**HARTFORD
MEMORIAL
HOSPITAL**
INCORPORATED

Re: Amendment to NRC Radioactive Materials License #48-18037-01

CHANGE IN LOCATION OF NUCLEAR MEDICINE DEPARTMENT: Enclosed please find a facility sketch representing the design of our new Nuclear Medicine Department.

NUCLEAR MEDICINE

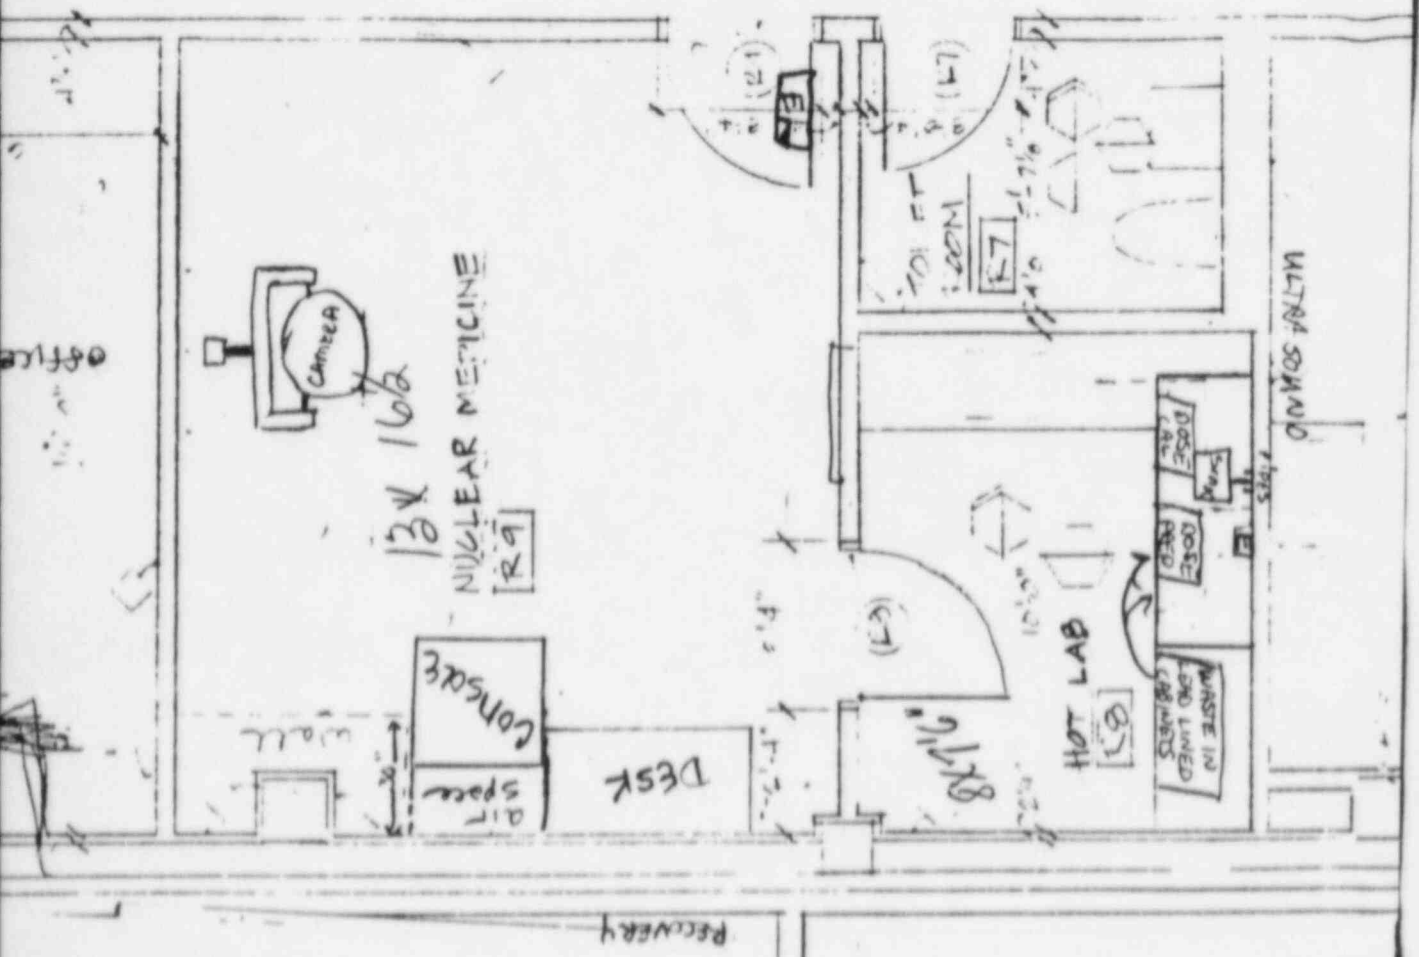
CHANGE IN LOCATION OF NUCLEAR MEDICINE DEPARTMENT: Enclosed please find a facility sketch representing the design of our new Nuclear Medicine Department.
